From: Michael Ruby <mrrubymichael@gmail.com>
Sent: Thursday, February 4, 2021 5:03 PM
To: Groth, Brian; ~BoS; Dobens, James; Dhima, Elvis; Planning; robert.scott@des.nh.gov; Scott Wade
Subject: Hudson Logistics Center

Re: Proposed Hudson Logistical Center – Unsatisfactory Sight-Line Study (using specific problems at 11 Fairway Drive)

Exhibit A: 11 Fairway Drive Orientation Picture and Sketch (for reference, shed is 16ft wide):

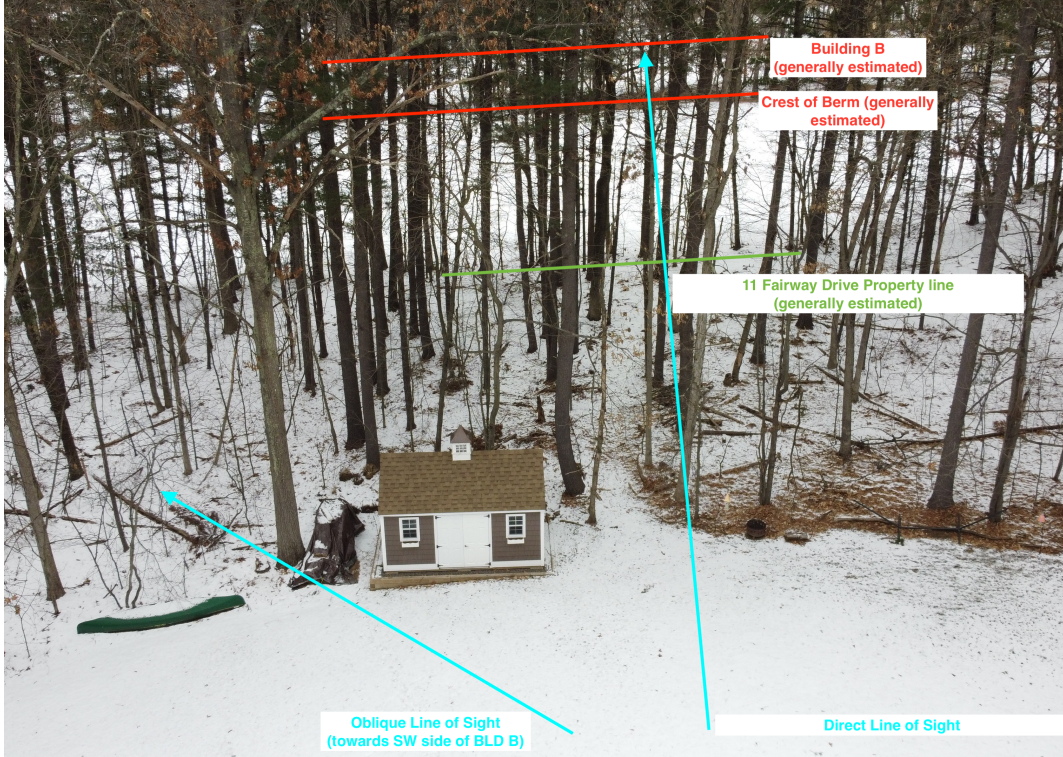
- **Missing Sight-Line-** When Hillwood's representatives came to my house on July 9th, 2020 they took two sets of photographs, to show how they could obscure building B and associated lighting:

- The first set of photos were looking directly towards the proposed berm (*the only set used in the January 27th 2021 presentation*).
 - the second set of photos were looking slightly left towards the river where the land drops 20-30 feet, exposing the southwest section of building B and associated lighting. Hillwood reluctantly said they would include this sightline because of the dramatic drop in elevation, **but it was missing in their presentation**.

- *Reference Exhibit A shows the orientation of these two sight-lines*
- **Excluding Other Sight-Lines-** Hillwood said they would reach out to Fairway and Eagle Drive houses that were across the street from abutters, as they also have direct views of the proposed buildings and the associated lighting. This was not done.

- **Blue lines** show sight lines Hillwood was supposed to complete (*only one was completed*)
- **Green line** shows how my property line is much further back (*or Hillwood's tree-line contribution is much shallower*) than Hillwood's depiction
- **Red Lines** show the proposed locations of the berm's crest and building B
- **Conclusion:** Hillwood's claims of providing obscurity are exaggerated and ineffective

Exhibit B: Hillwood's rendering

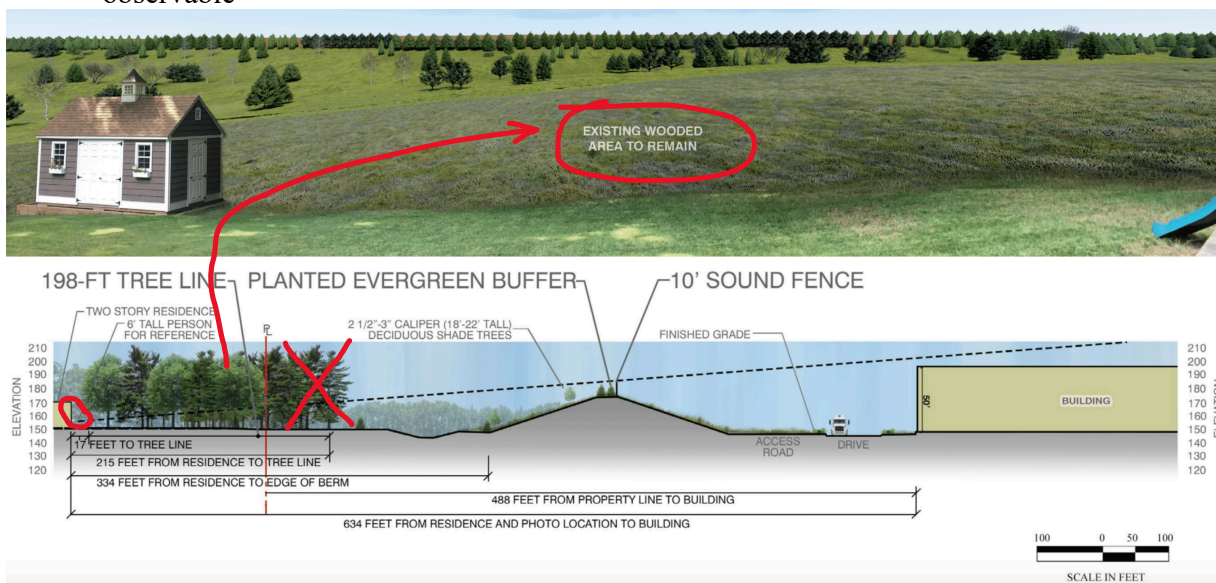
- **"Cartoonish" Sight-Line Renderings-** Hillwood's sight-line renderings look oddly deceptive, presumably due to their wide-angle perspective which distorts distances between objects and creates their signature "prairie-like" views.

- Exaggerates the amount of tree-line Hillwood contributes
- Hillwood claims "existing wooded area to remain"... ~90-95% of these woods are my property; therefore, this is my choice, not Hillwood's!
- Sight-line starts too low at 6 feet... Real elevation is higher, presumably making building B observable
